Product Change Notification / GBNG-17ZWEX736

CCB 4959 Final Notice: Qualification of MMT as a new assembly site for selected SMSC LAN91C11xx device family available in 128L TQFP (14x14x1mm) package.

**CCB No. 4959**

**ASE**

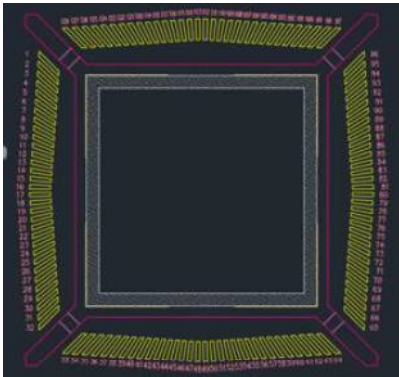
Lead frame paddle size	240 x 240 mils
Lead frame DAP surface prep	Double Ring

**MMT**

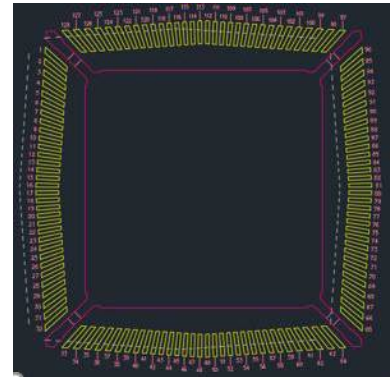
Lead frame paddle size	252 x 252 mils
Lead frame DAP surface prep	Bare Cu
